L. William Pearce
Site Vice President724-682-5234
Fax: 724-643-8069June 2, 2004
L-04-073U. S. Nuclear Regulatory Commission
Attention: Document Control Desk
Washington, DC 20555-0001**Subject: Beaver Valley Power Station, Unit No. 1 and No. 2**
BV-1 Docket No. 50-334, License No. DPR-66
BV-2 Docket No. 50-412, License No. NPF-73
License Amendment Request Nos. 317 and 190

ENCLOSURE 1
FENOC Evaluation of the Proposed Changes

Beaver Valley Power Station
License Amendment Requests
317 (Unit 1) and 190 (Unit 2)

Subject: Application to Permit Beaver Valley Power Station Unit Nos. 1 and 2 Operation with an Atmospheric Containment Design.

FIGURE 3.6-1

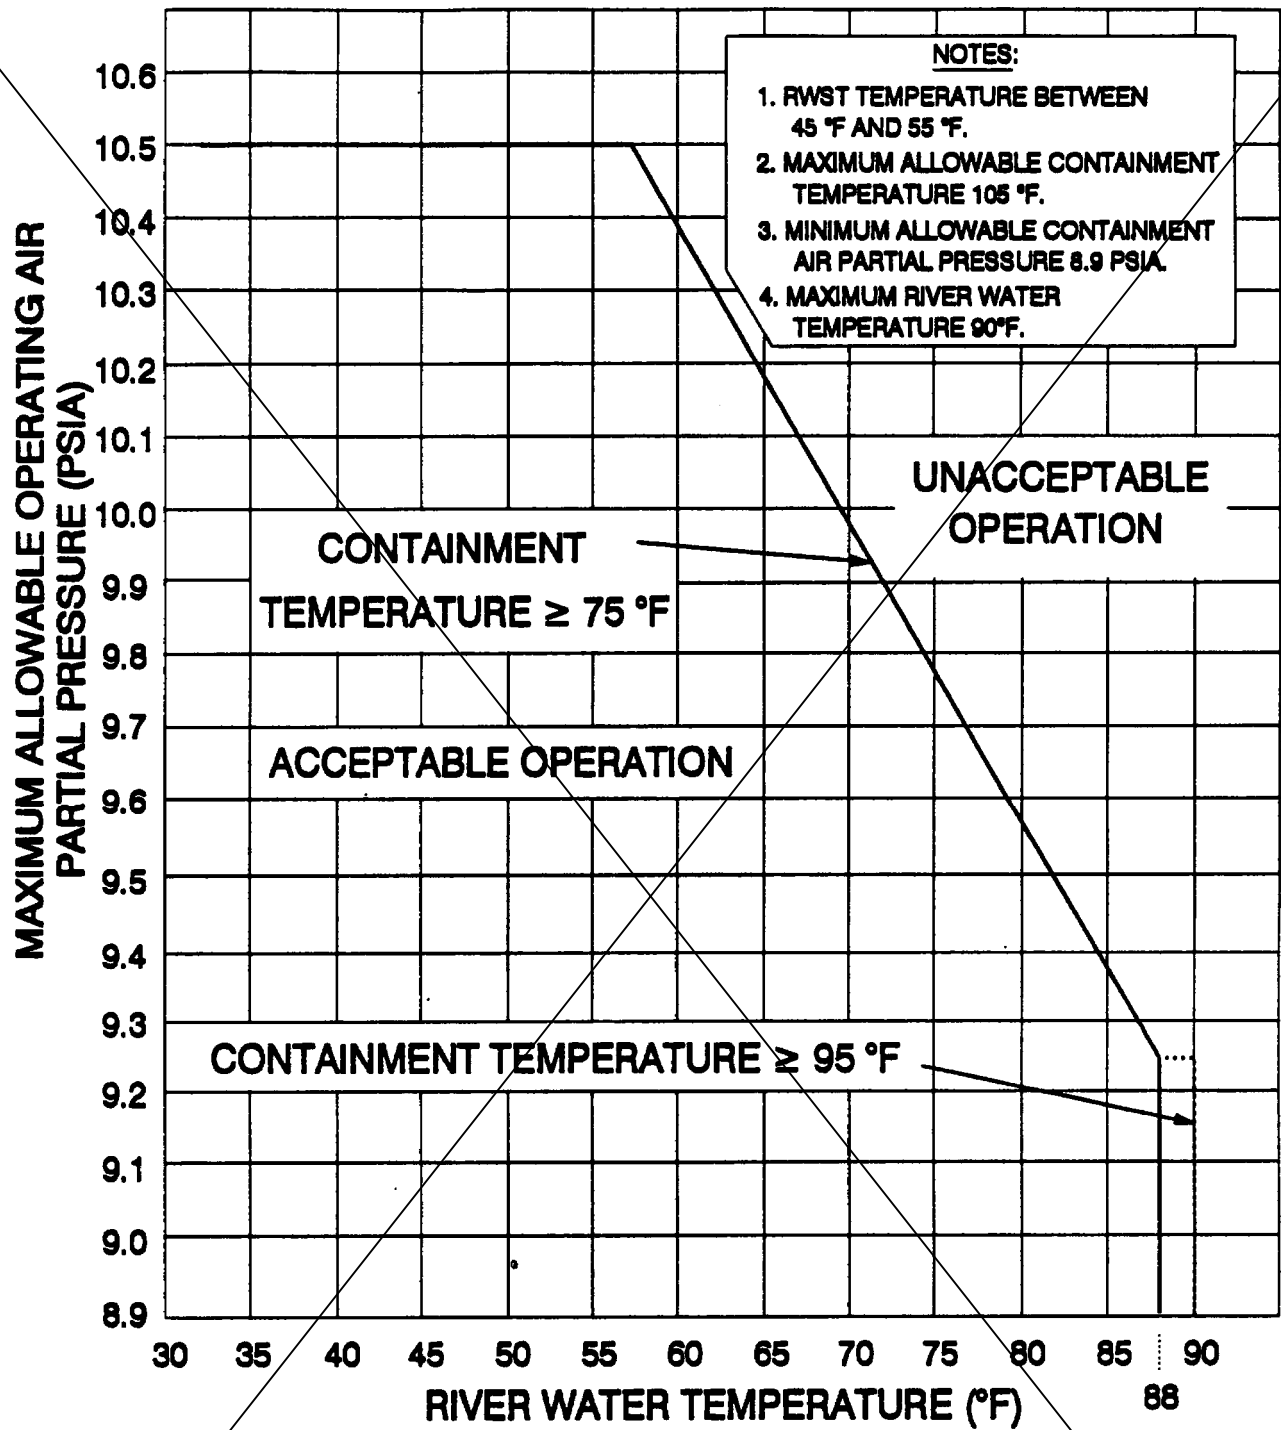
In this change Technical Specification 3.6.1.4, Internal Pressure, is revised by replacing the air partial pressure requirement with a containment total air pressure requirement of ≥ 12.8 psia and ≤ 14.2 psia. This change eliminates the need for Figure 3.6-1. The word "primary" is also removed from the Limiting Condition for Operations (LCO) statement of this specification.

3.6.1.4 ~~Primary Containment internal air partial pressure shall be maintained ≥ 8.9 PSIA and within the acceptable operation range (below and to the left of the applicable containment temperature limit line(s)) shown on Figure 3.6-1 as a function of river water temperature.~~ Containment internal air pressure shall be ≥ 12.8 psia and ≤ 14.2 psia.

With the containment internal air ~~partial~~ pressure ~~< 8.9 PSIA or above the applicable containment temperature limit line(s) shown on Figure 3.6-1,~~ not within the above limits, restore the internal pressure to within the limits within 1 hour or be in at least HOT STANDBY within the next 6 hours and in COLD SHUTDOWN within the following 30 hours.

The proposed change, including the deletion of Figure 3.6-1, is consistent with the Improved Standard Technical Specifications (ISTS) LCO for an atmospheric containment design. The revised containment analyses assumptions for initial containment air pressure are ≥ 12.8 psia and ≤ 14.2 psia. The proposed containment total air pressure range will ensure that the containment operating pressure is maintained within these analysis limits. See Section 4.3 of Enclosure 2 for input parameters and assumptions used in the containment analysis. Deletion of the word "primary" from the LCO statement is an administrative change made to conform to the ISTS.

FIGURE 3.6-1

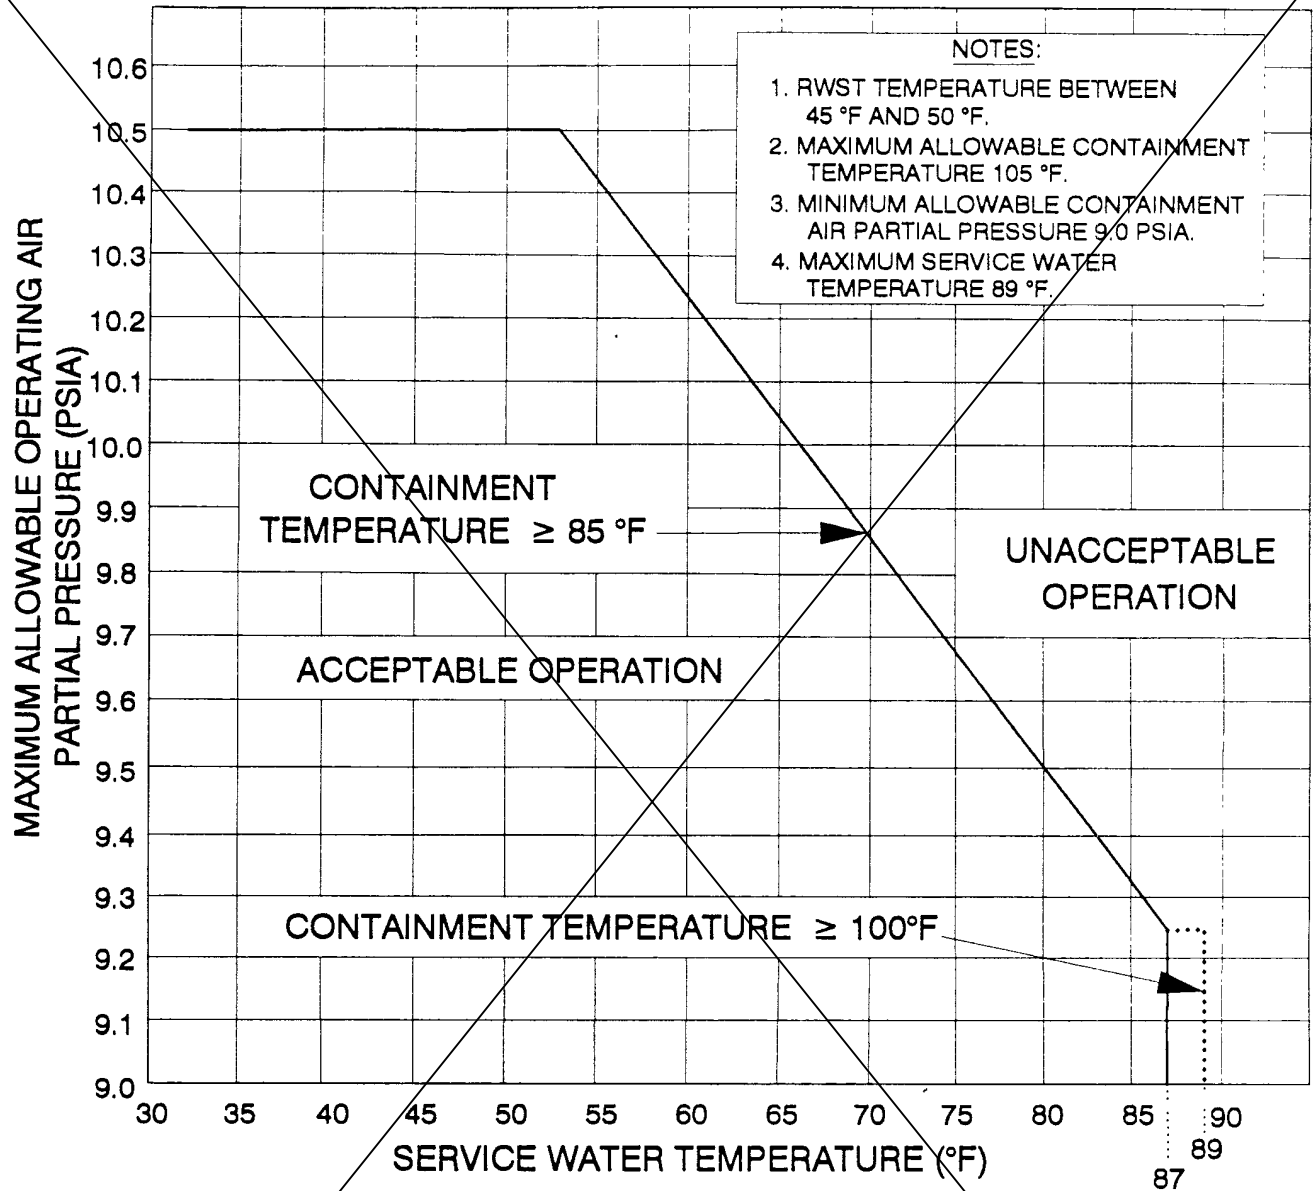
3.6.1.4 ~~Primary Containment internal air partial pressure shall be maintained ≥ 9.0 psia and within the acceptable operation range (below and to the left of the applicable containment temperature limit line) shown on Figure 3.6-1 as a function of service water temperature.~~ Containment internal air pressure shall be ≥ 12.8 psia and ≤ 14.2 psia.

With the containment internal air ~~partial~~ pressure ~~≤ 9.0 psia or above the applicable containment temperature limit line shown on Figure 3.6-1,~~ not within the above limits, restore the internal pressure to within the limits within 1 hour or be in at least HOT STANDBY within the next 6 hours and in COLD SHUTDOWN within the following 30 hours.
